DA2025/006

12 JUBILEE AVENUE, BRIGHTON

### **MULTIPLE DWELLINGS X 13 (12 NEW & 1 EXISTING)**

# APPLICATION FOR PLANNING PERMIT (DA 2025 / 00006) MULTIPLE DWELLINGS X 13 (12 NEW AND 1 EXISTING), 12 JUBILEE AVENUE, BRIGHTON

# CIVIL DRAWINGS UNIT DEVELOPMENT 12 JUBILEE AVENUE BRIGHTON

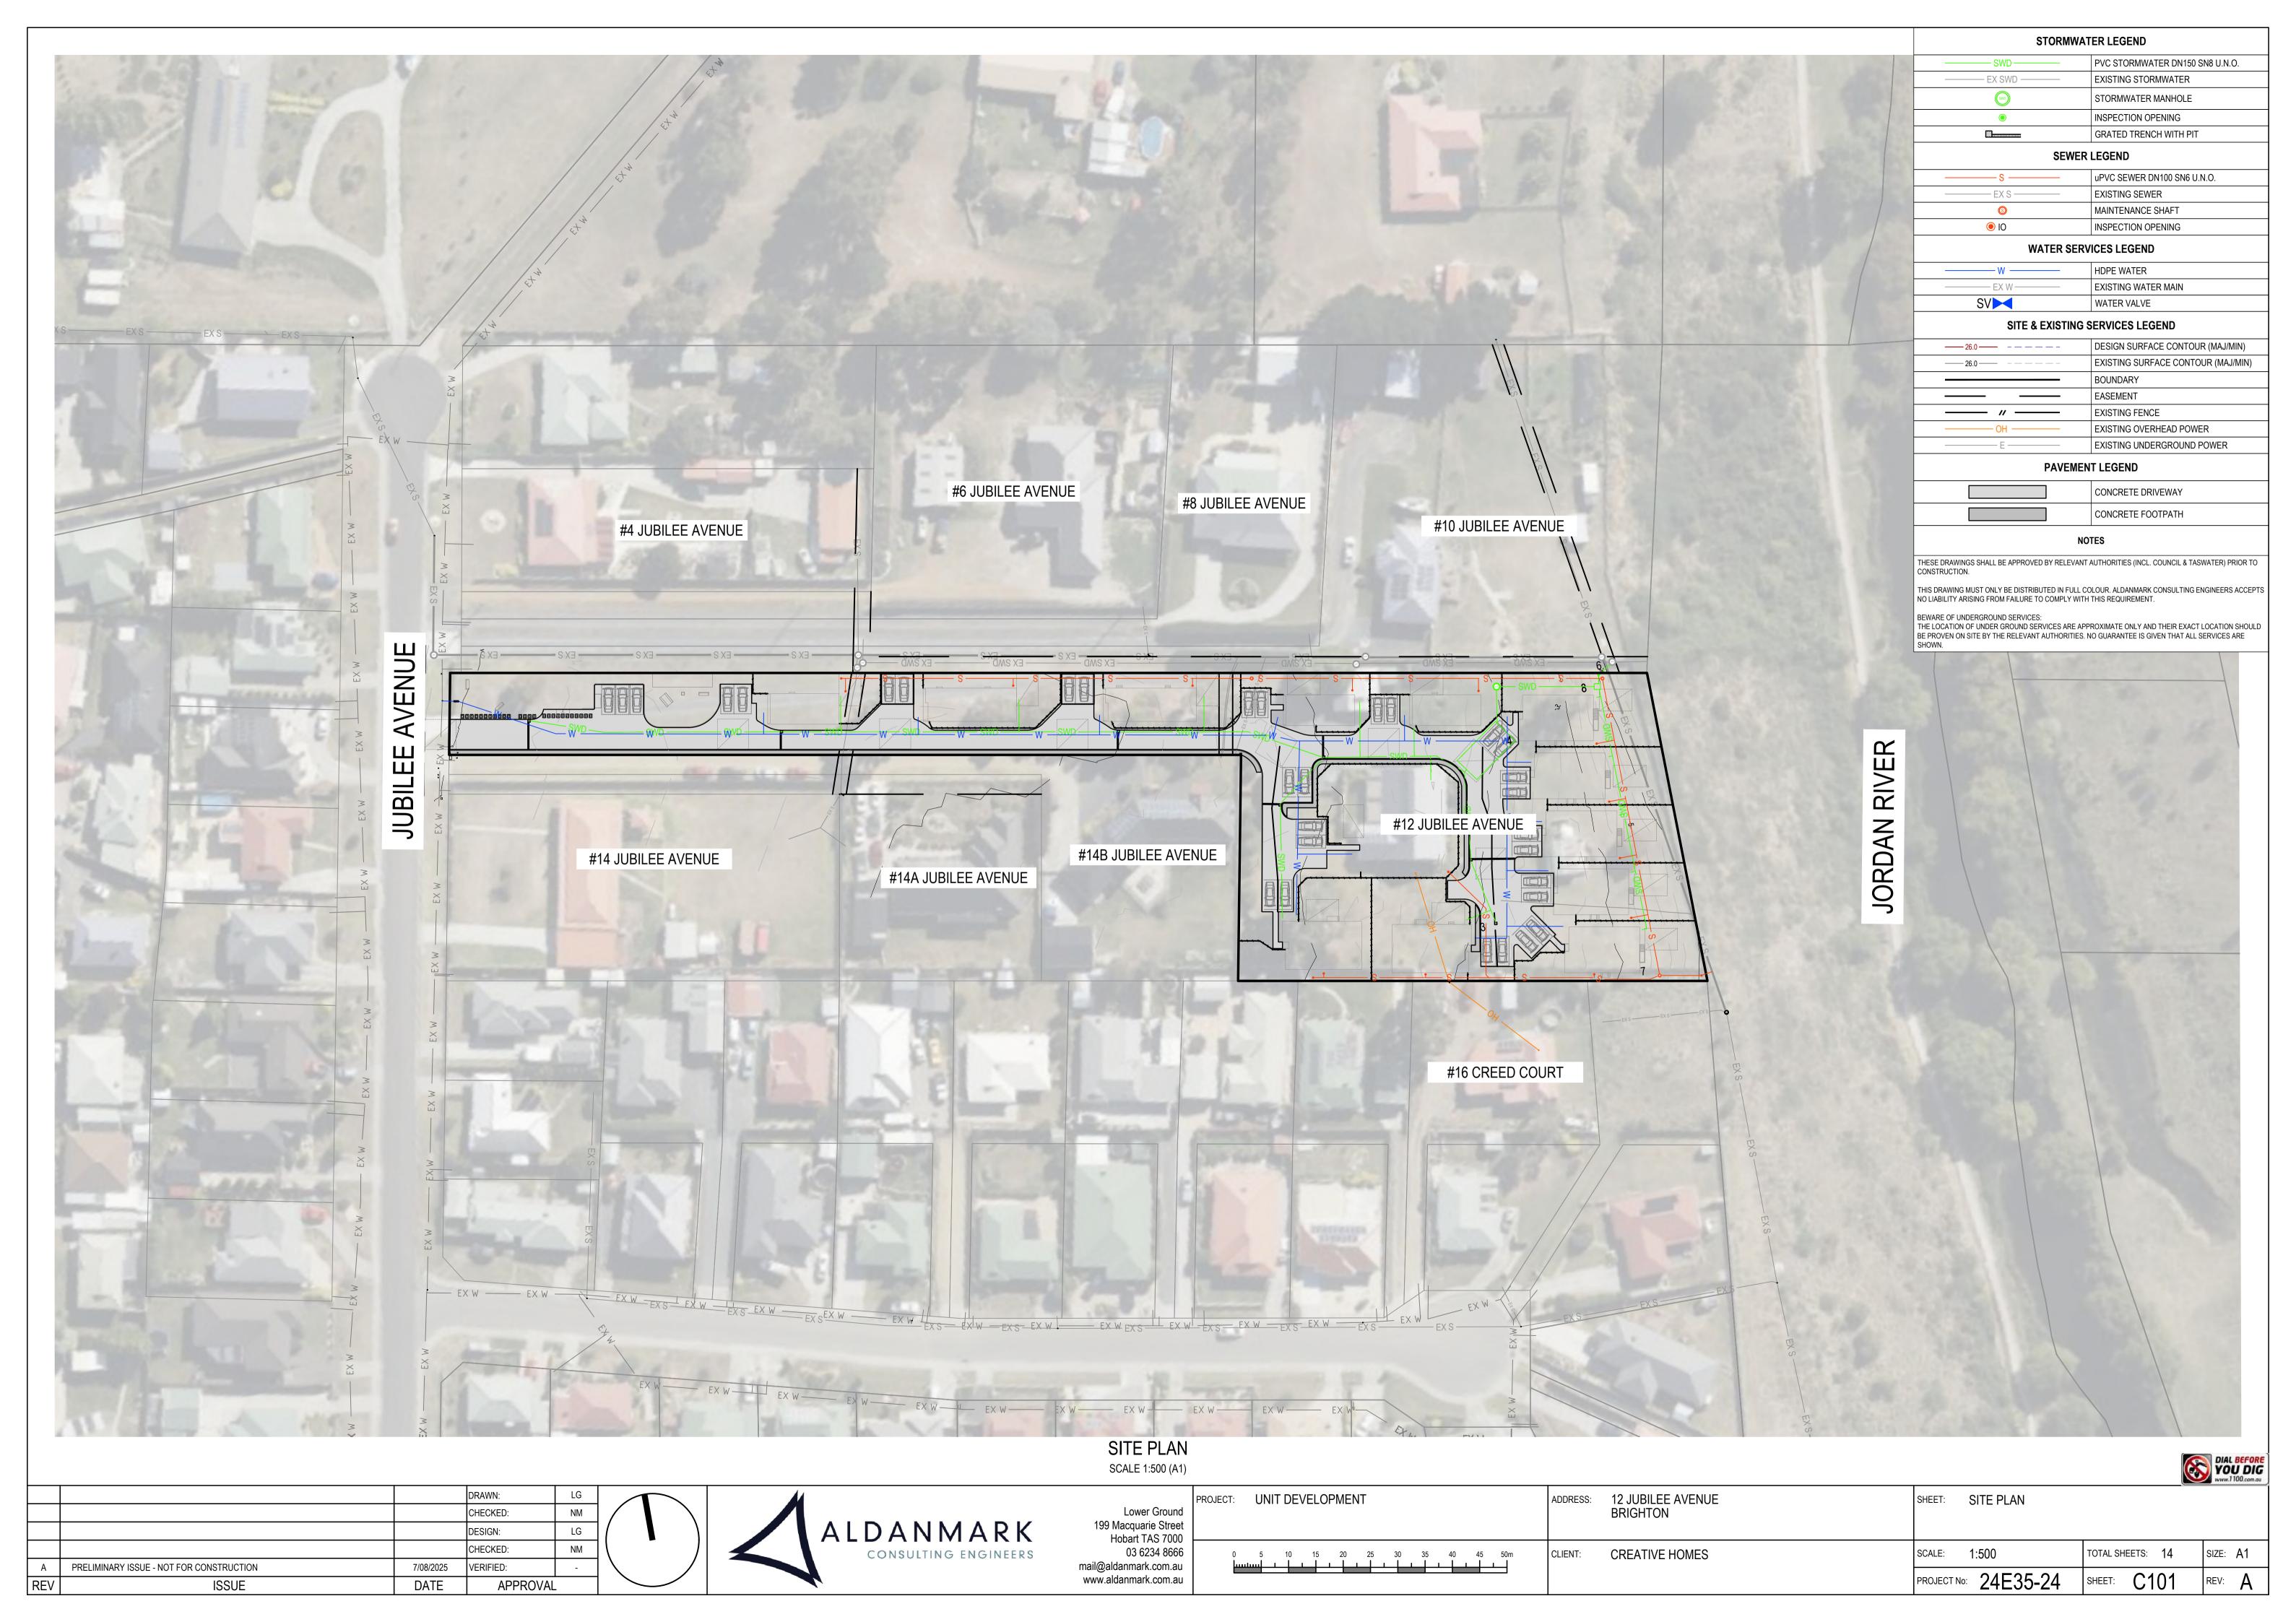
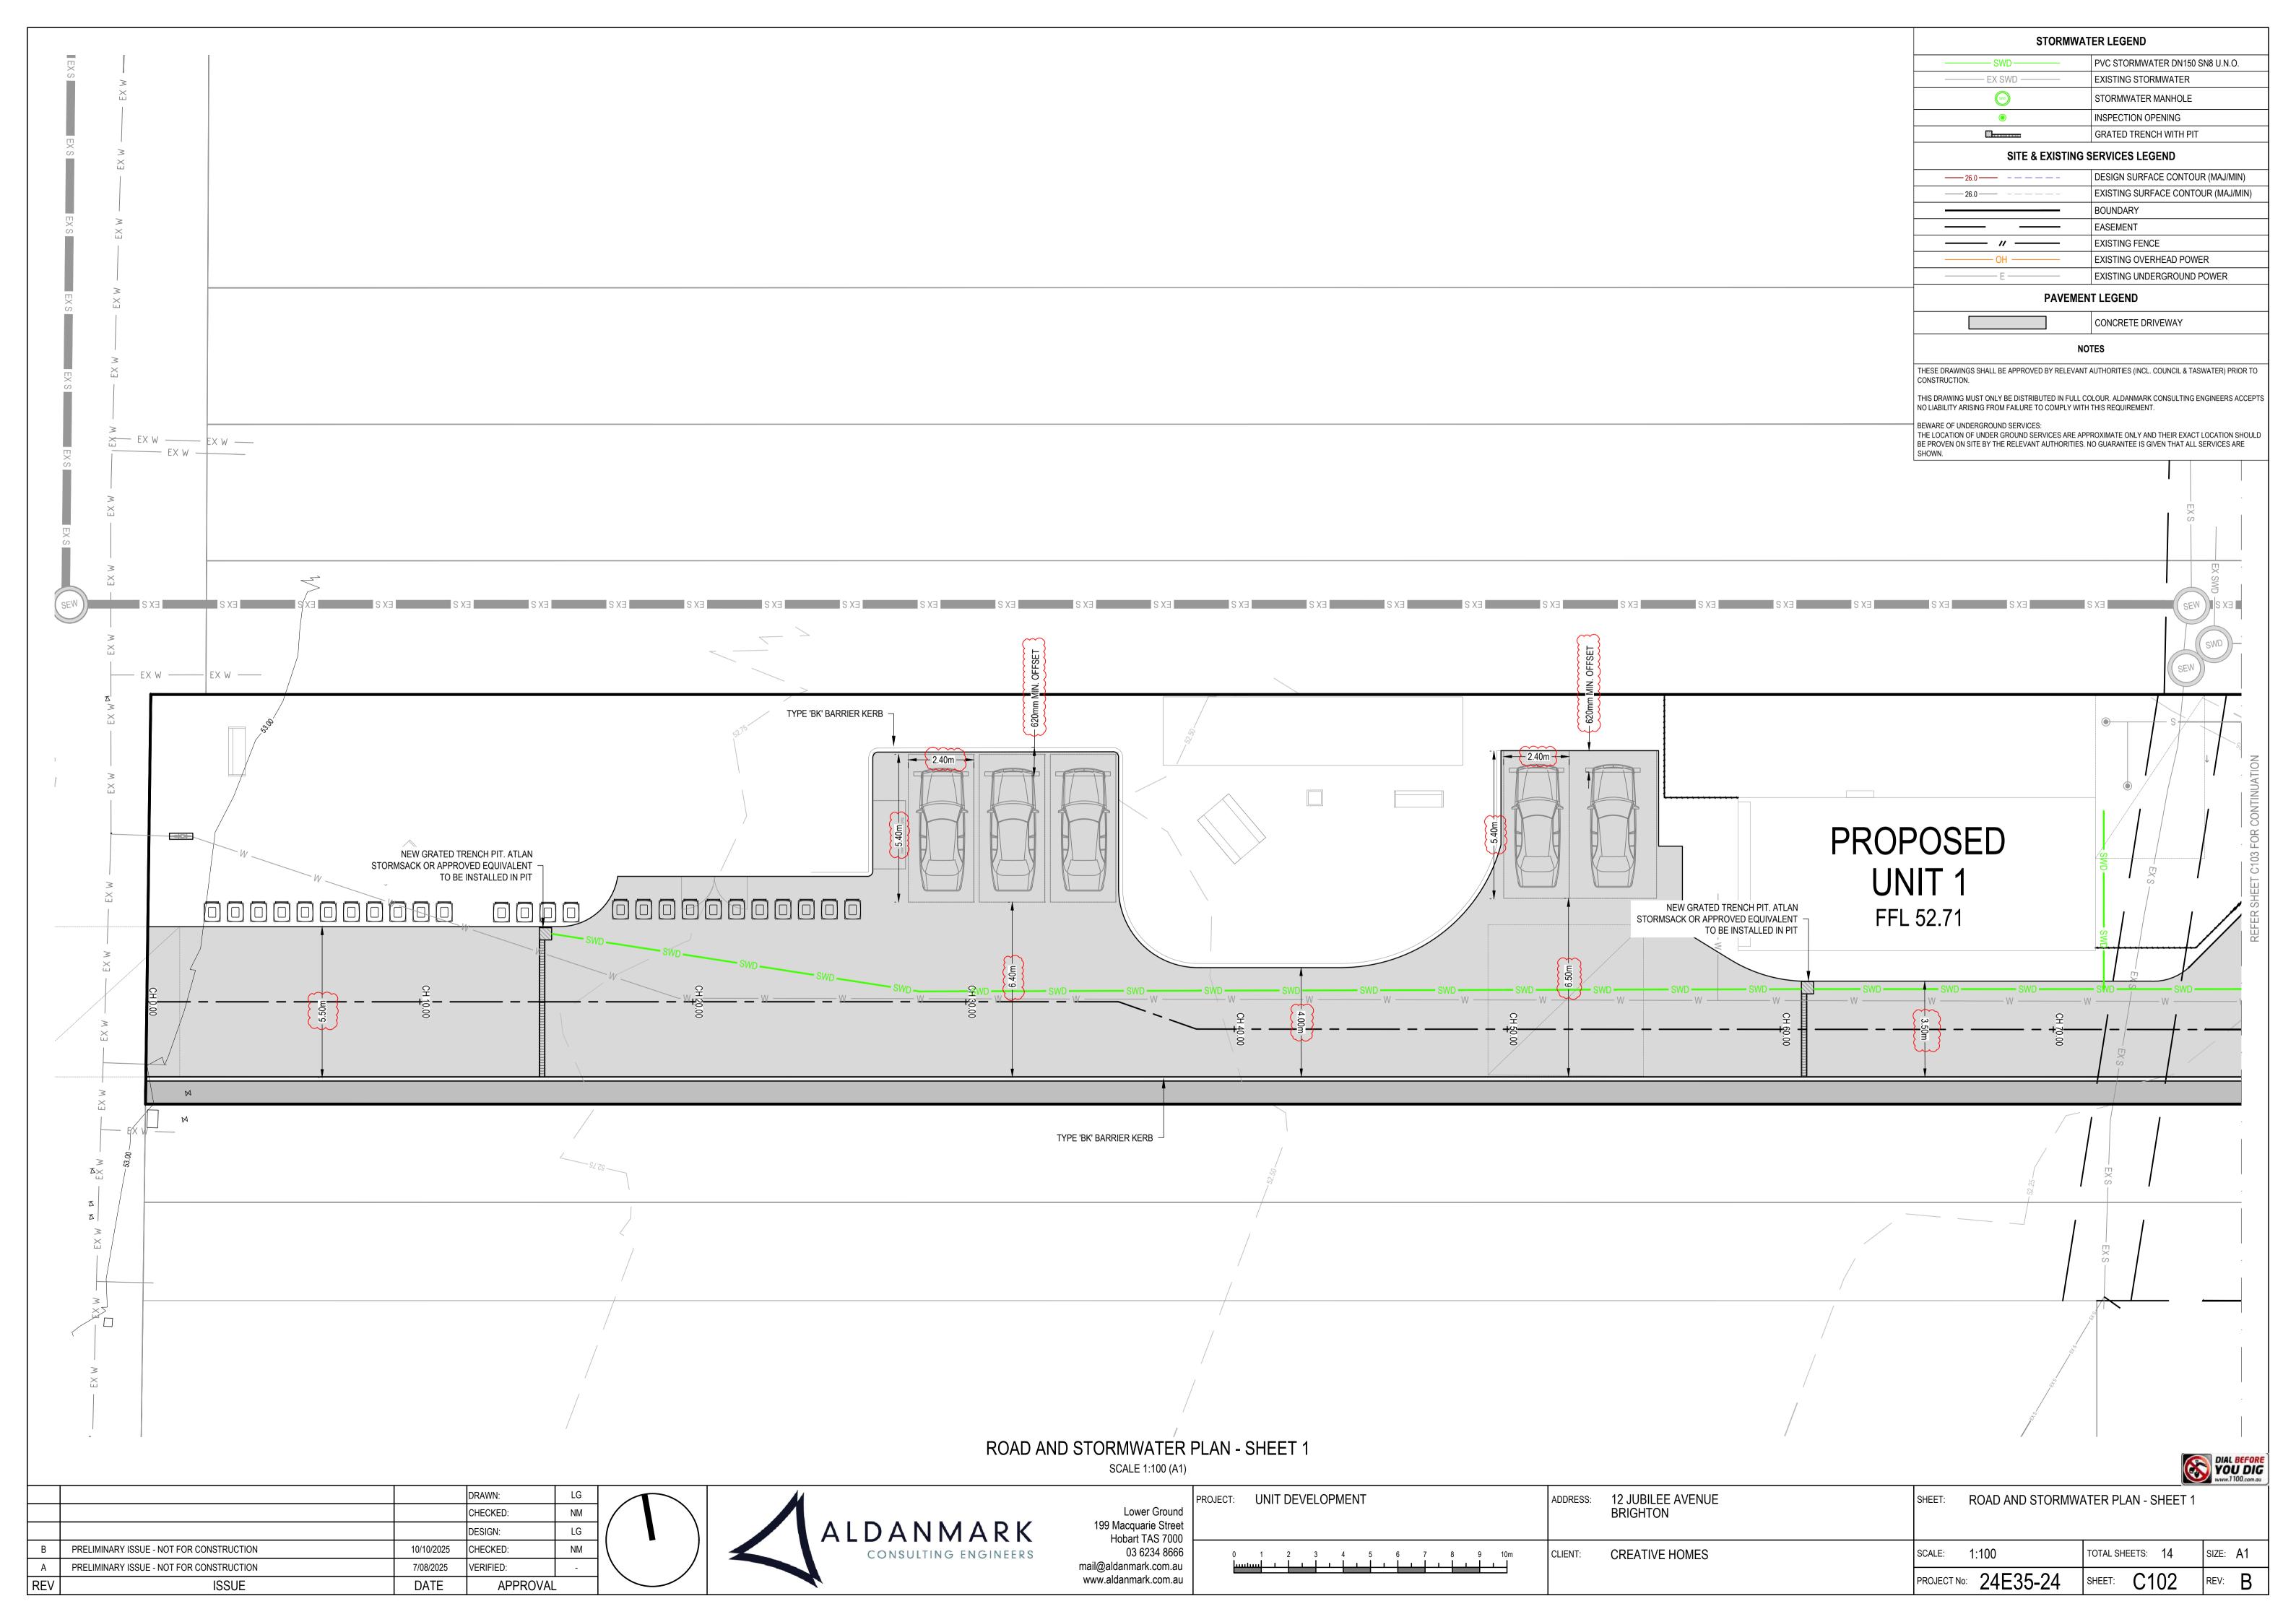
RFI CONDITION	COMMENTS	AMENDMENTS	ALDANMARK DRG REFERENCE	
4(a)	Provide a revised plan set that addresses C2.6.2 A1.1 (iii) in particular providing a 5.5m carriage way throughout or provides passing bays that include workable tapers and are orientated to accommodate the flow of traffic. Turning sweeps should be shown at each passing bay.  Adequate tapers have been provided for all passing bays, are oriented to the flow of traffic and have turning paths shown as per Sheets C110 – C113 RevB			
4(b)	Provide a revised plan set that addresses C2.6.2 A1.1 (v) provide parking bays throughout that meet the requirements of Table C2.3 including which do not encroach upon pedestrian access ways.	No parking bays are shown encroaching on pedestrian access ways.	C110 – C113 RevB	
4(c)	In accordance with 2.6.5 A1.1 parts (a) and (b) including with a pedestrian throughfare that has a surface raised 150mm above that of the roadway and is not encroached with vehicle reversing.	Type 'BK' Barrier Kerb as per LGAT drawing TSD-R14-v3 has been noted on Sheets C102 - C105 RevB. Footpaths match into the back of 150mm high kerb. Aisle widths from the carpark to the kerb have been shown on Sheets C102 - C105 RevB for all car parks and are above the minimum requirement of 5.8m for User Class 1A as per AS2890.1. This allows for adequate space for reversing without encroaching, as deemed by AS2890.1	C102 - C105 RevB

N/a	Council comment regarding Unit 4 passing bay:  Picture above of the internal intersection change of direction occurring at unit 4 that has not been taken into account if a vehicle wishes to turn left entering from the right. Proof or an understanding of this action is required.	Aldanmark considers the vehicle entering from the right and turning left at the intersection outside of Unit 4 an improbable scenario. Only vehicles accessing the existing dwelling and the proposed Unit 12 will enter this section of the driveway, which would be from the left of page. This intersection is the widest	C113 RevB

part of the driveway which has sufficient space for turning and an adequate carriageway width of 3.5m has been provided at the exit to the existing dwelling and proposed Unit 12.	
12	It is noted that 16 Creed Court currently provides overhead power supply to 12 Jubilee Avenue via	This is not Aldanmark's decision. Creative Homes to address.	N/a
	a private pole. Please confirm whether this existing overhead supply will be removed and replaced with an underground connection.
